RE: Florida Department of Environmental Protection Letter Dated May 21, 2007, DEP File Number 0930104-014-AC, Application No. 1270-2, Okeechobee Landfill Facility, Okeechobee Landfill, Inc.

Re: Response to FDEP Letter Dated May 21, 2007 OLI Class I Area Impact Analysis
FDEP File Number: 0930104-014-AC

RE: Florida Department of Environmental Protection Letter Dated April 2, 2007, DEP File Number 0930104-014-AC, Application No. 1270-2, Okeechobee Landfill Facility, Okeechobee Landfill, Inc.

RE: Florida Department of Environmental Protection Letter Dated April 2, 2007, DEP File Number 0930104-014-AC, Application No. 1270-2, Okeechobee Landfill Facility, Okeechobee Landfill, Inc.

Landfill and Stack Locations

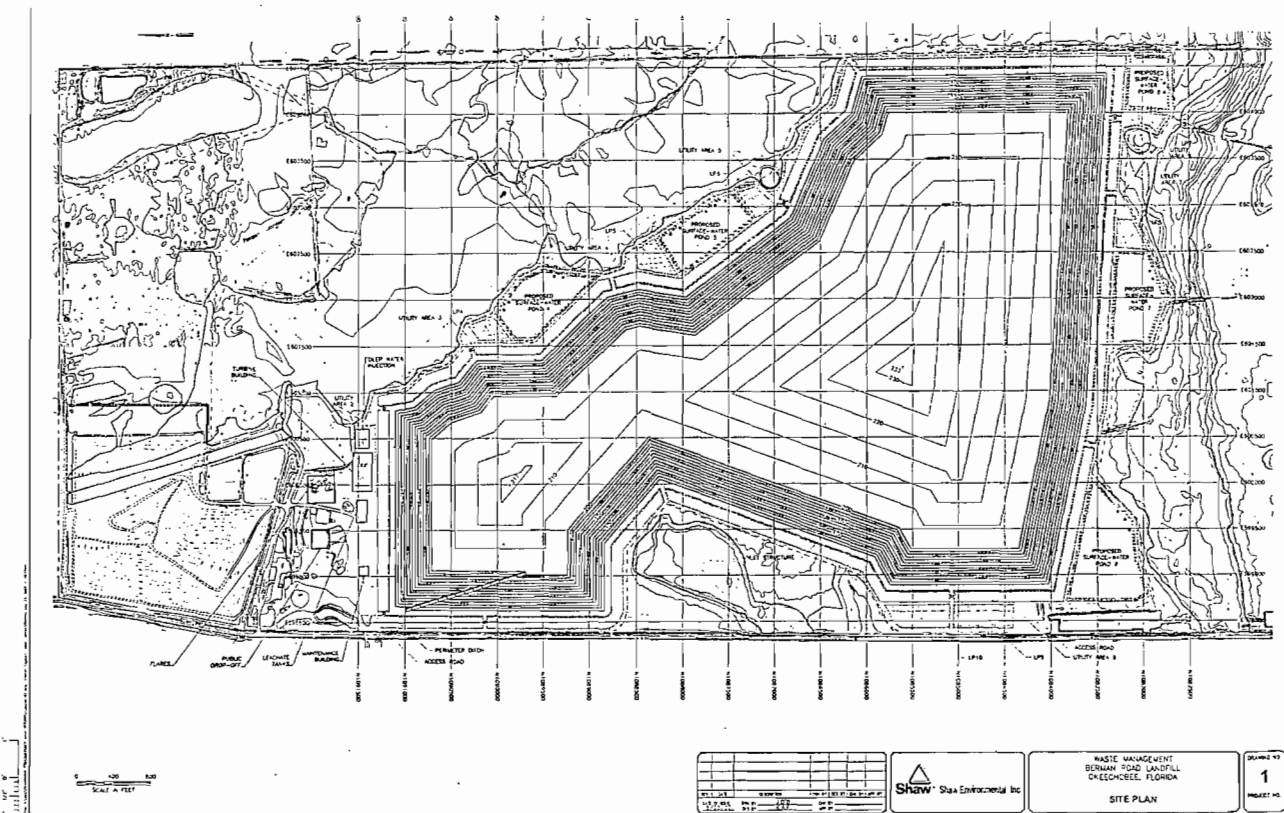
Comment No. 2: Please explain how the terrain of the landfill was modeled. For example, was the existing landfill included in the terrain or was it assumed that the landfill was mostly flat? Provide guidance that was used in determining how to model the landfill terrain.

Response: Shaw Environmental, Inc. conducted a Good Engineering Practice (GEP) stack height evaluation for the landfill to determine potential for aerodynamic downwash and determined that the landfill did not influence building downwash. Shaw followed the guidance established in USEPA's Guidelines for Determination of Good Engineering Stack Height (USEPA 1995a). **Attachment 1** shows the distance from the capped landfill to the location of the turbine and flare stacks as well as the height of the capped landfill.

ATTACHMENT 6
Average Annual Gas Potential Curve

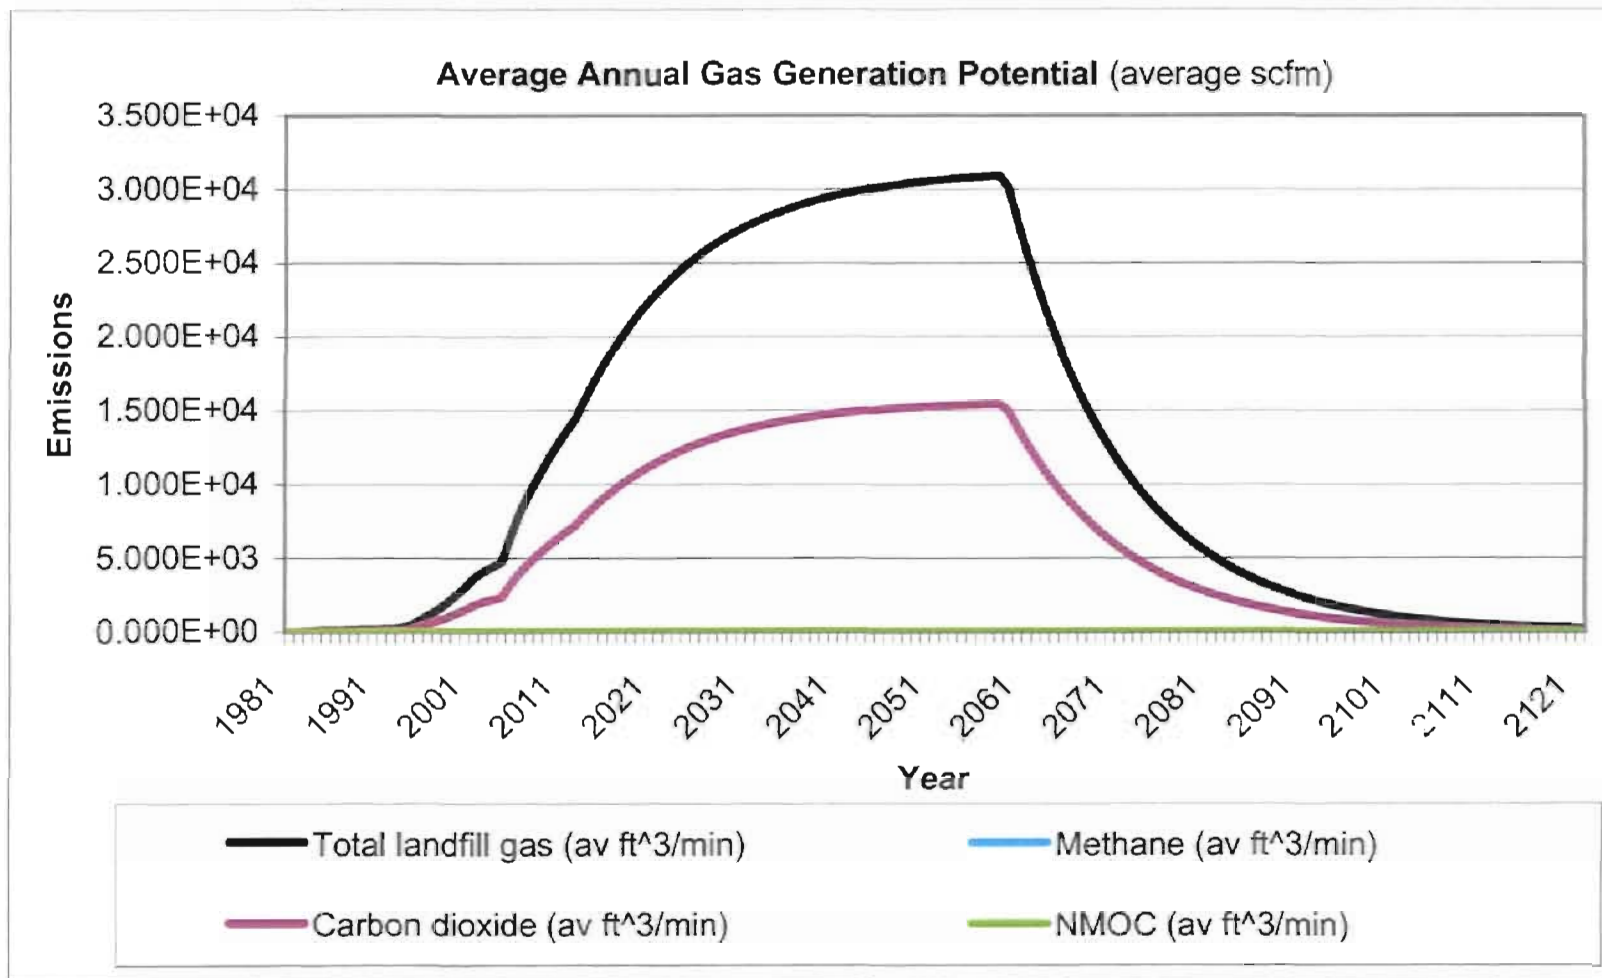
Comment No. 1: In the application the capacity of the landfills is mentioned in the Support Documentation Section II., subsection 3.3.1. and in Appendix E, LFG (Landfill Gas) Generation Rates & Construction Schedule. The landfill capacity is important in defining the potential to emit for the facility. While on-site and as mentioned in the application, two solid waste permits apparently exist for the existing site and the proposed new site. The solid waste permits referenced are Permit Number 0040842-010-SC for the Berman Road Landfill site and Permit Number 0247963-001-SC for the Clay Farms Landfill site.

- a. The entire property consists of 4,150 acres (corrected from the 4,300 estimate); however, the permitted solid waste disposal footprint is only 833 acres of the total property acreage. **Attachment 5** includes copies of the permit pages with the stated acreage.
- b. A landfill gas generation potential curve is at **Attachment 6** of this letter. Please note the Berman Road and Clay Farm areas are not separate stationary sources. Clay Farms is not a proposed new site, but a permitted capacity increase of the existing stationary source. The nomenclature is used to distinguish the areas.
